ADDENDUM NO. 02

RANKIN TRAILS AMPHITHEATER AND BASEBALL PARK

Rankin County, Mississippi

WBA Proj. # 2215/2315

AMPHITHEATER
UTILITY LAYOUT

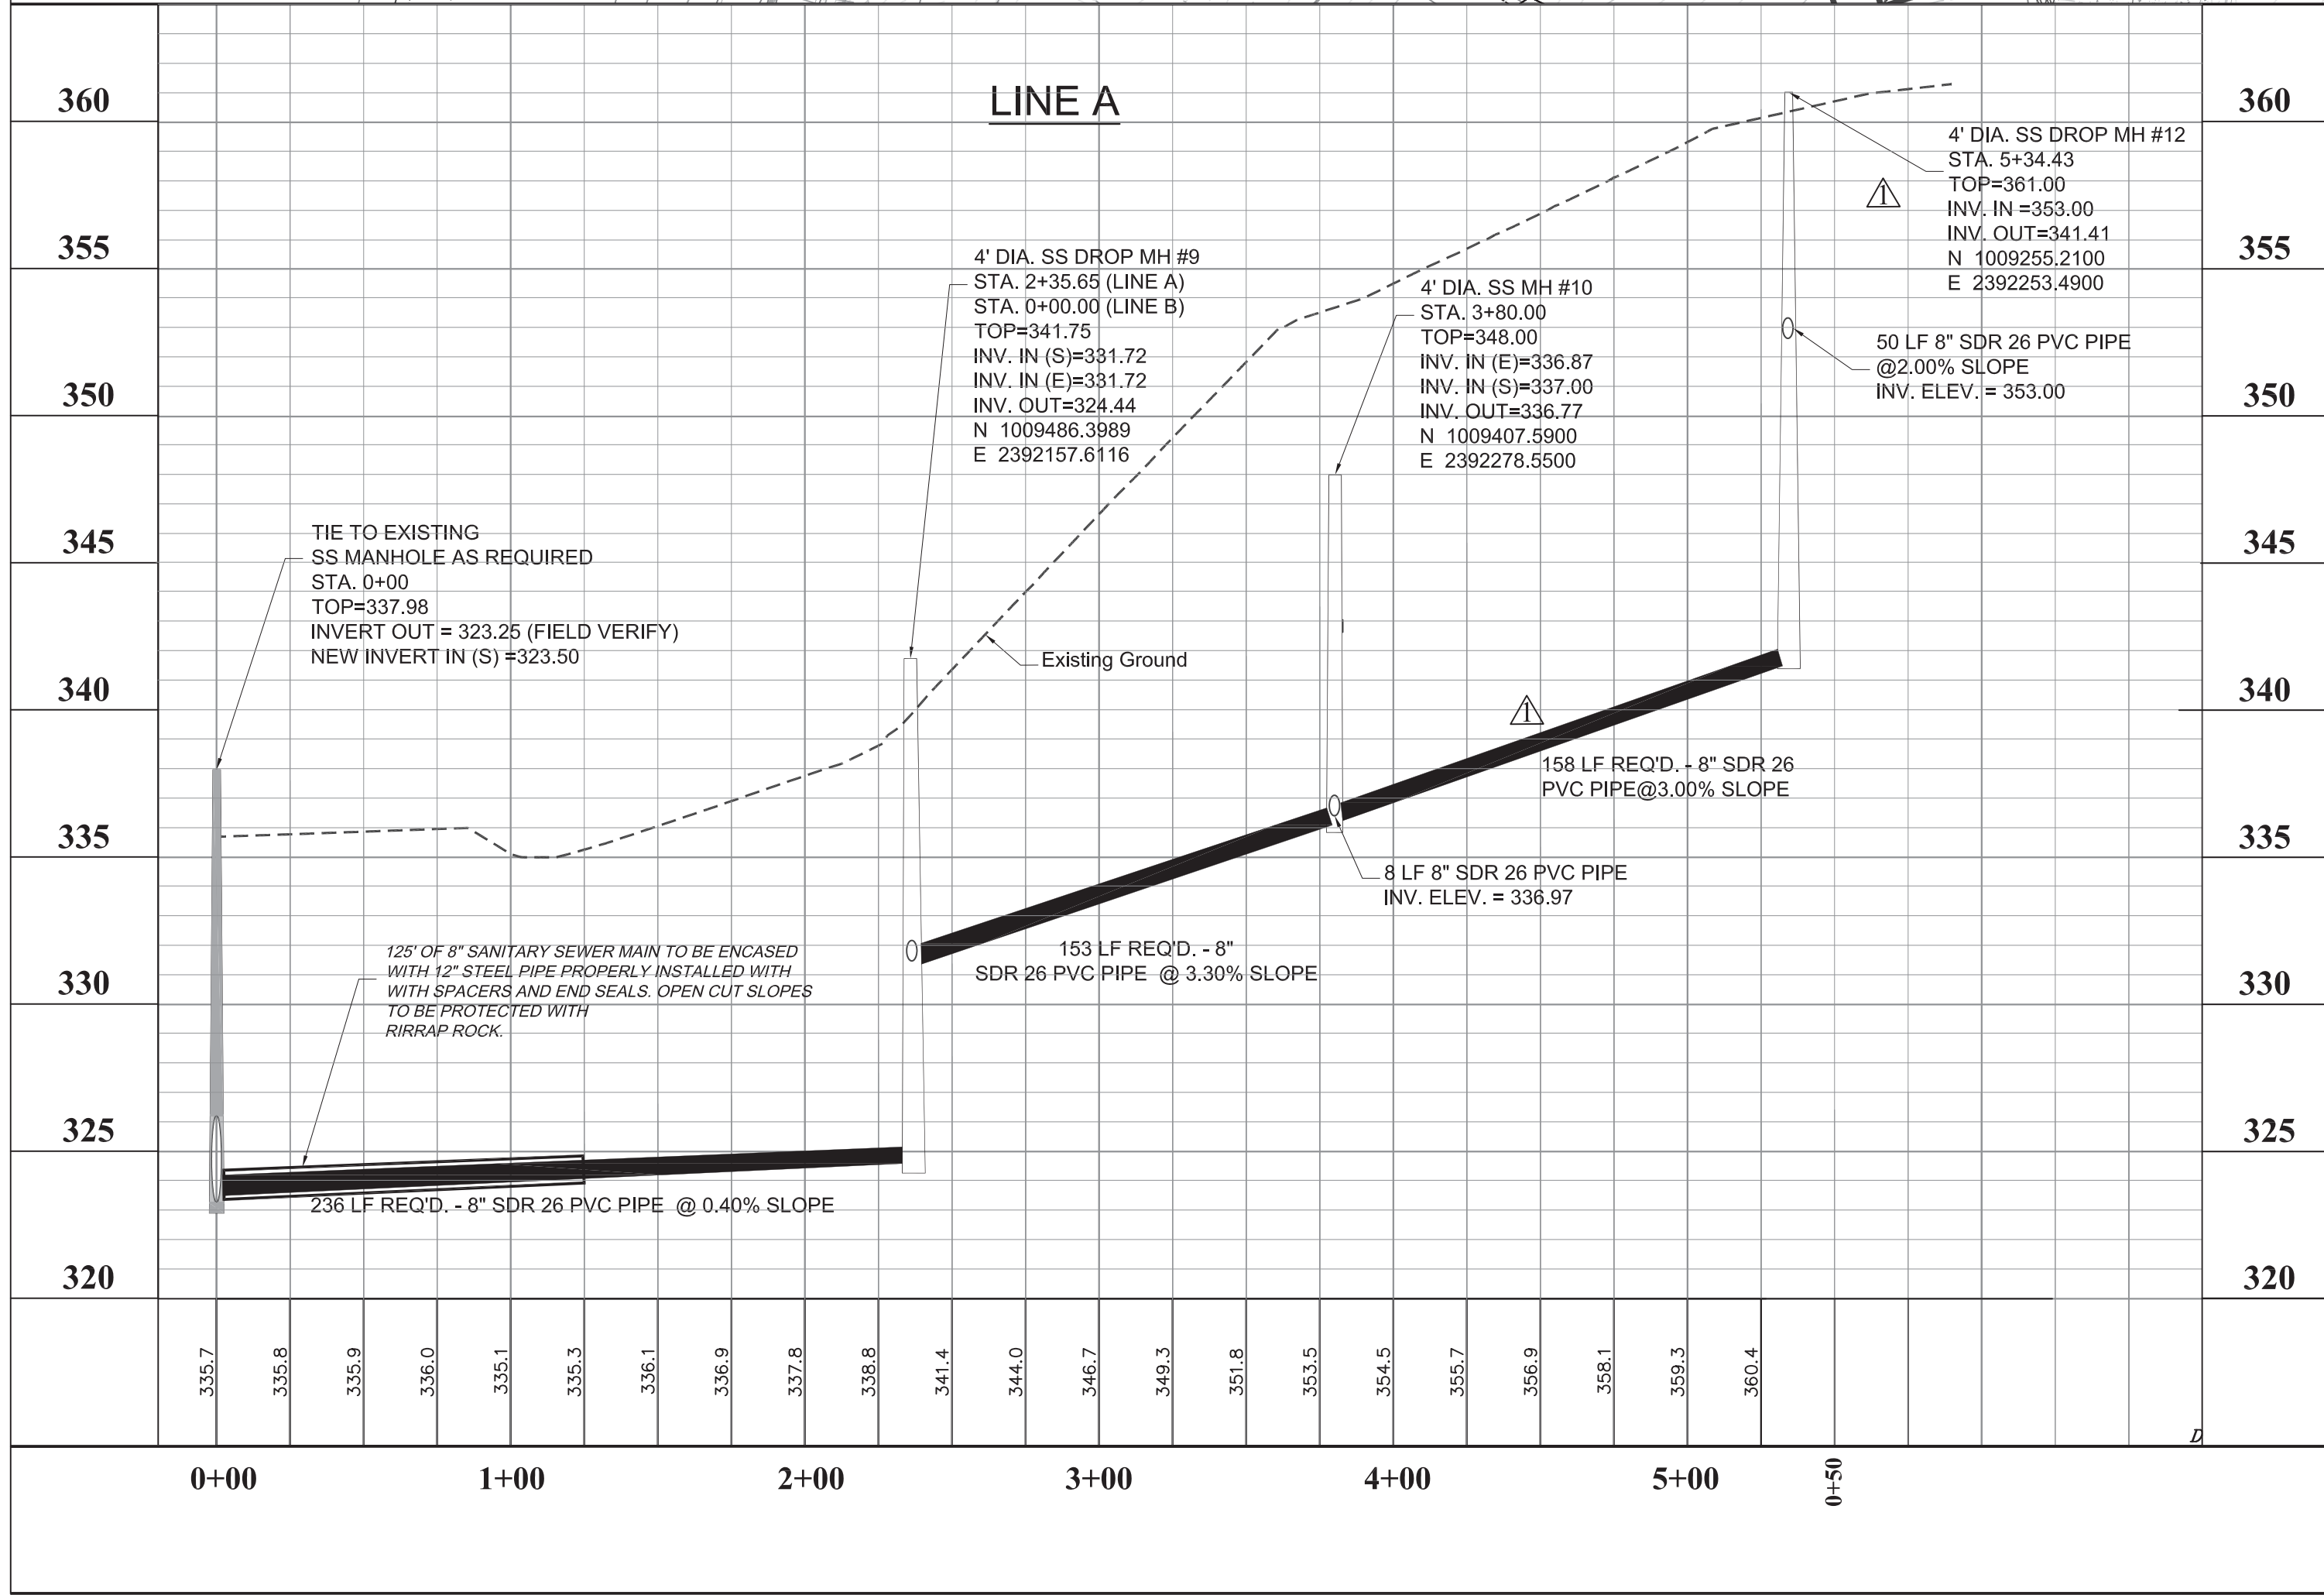
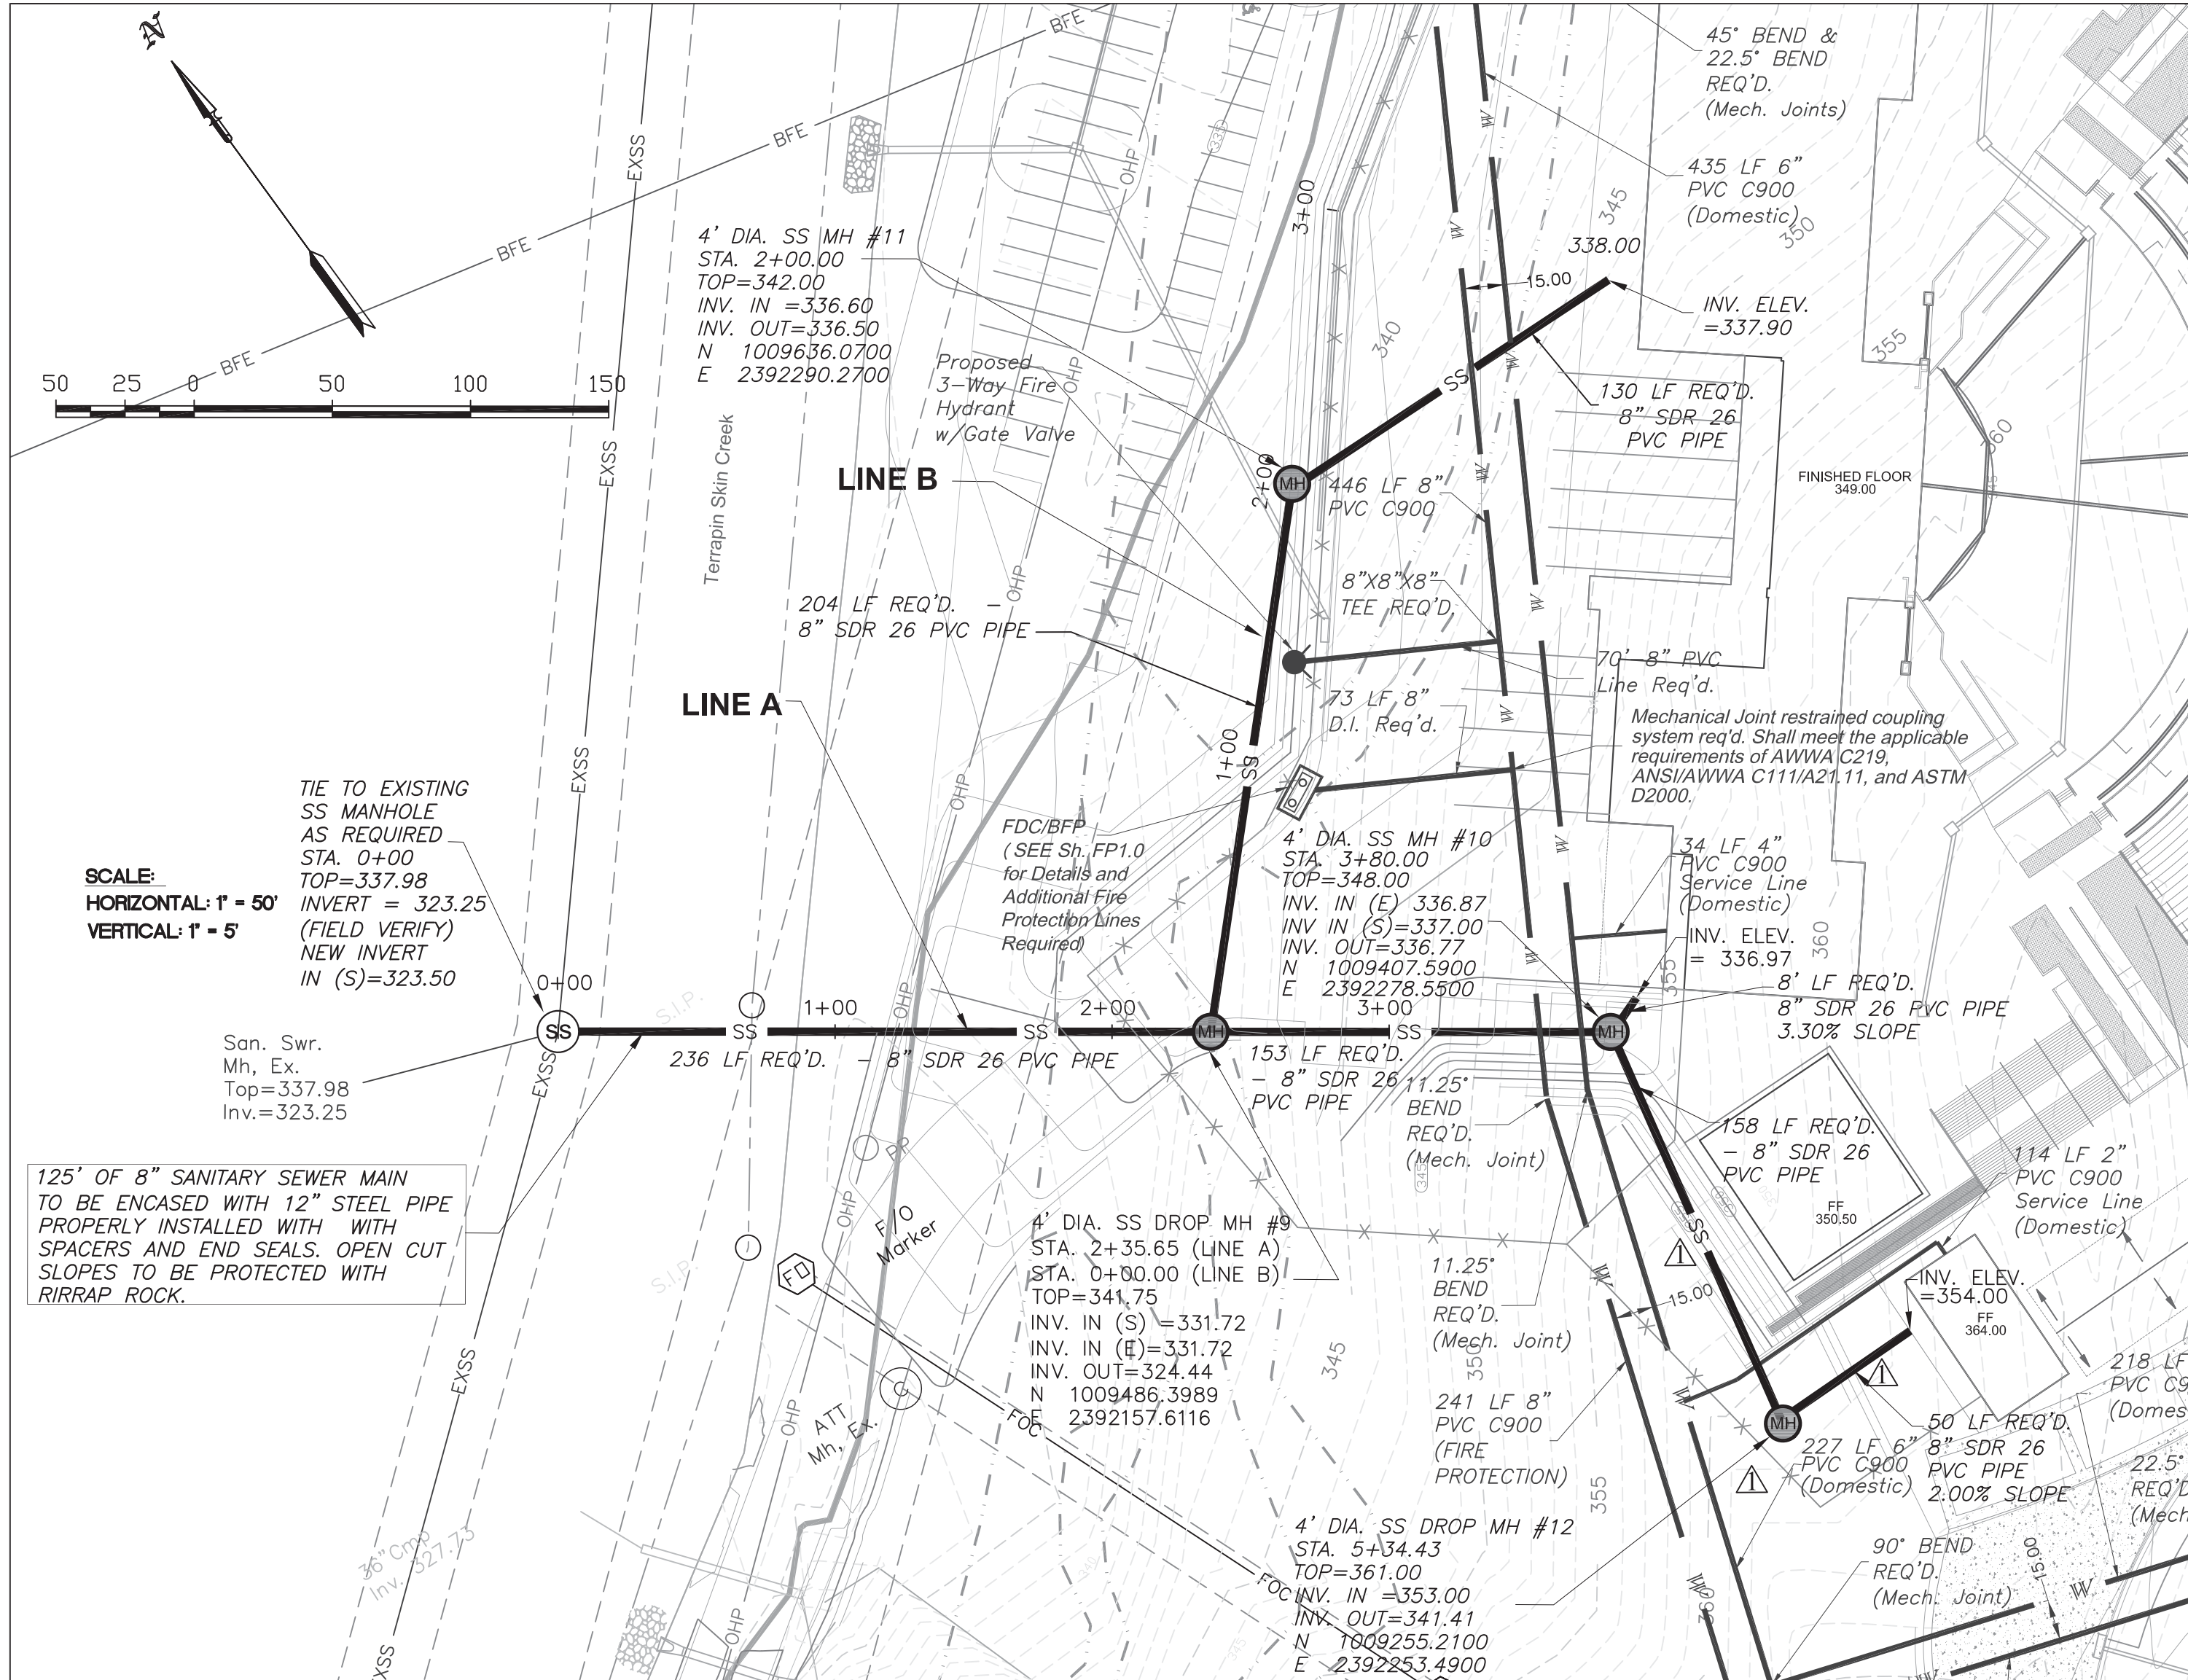
- ITEM NO. 15 SHEET C4.0 AMPHITHEATER UTILITY LAYOUT**
REVISE per enclosed sheet C4.0. Revised water lines per Fire Dept. comments.
- ITEM NO. 16 SHEET C4.1 AMPHITHEATER SANITARY SEWER PLAN-PROFILE**
REVISE per enclosed sheet C4.1. Revised water lines per Fire Dept. comments.

REVISIONS		
NO.	DESCRIPTION	DATE
1	ADDED FDC, SUPPLY LINE AND WATER SERVICE LINES	7/14/16
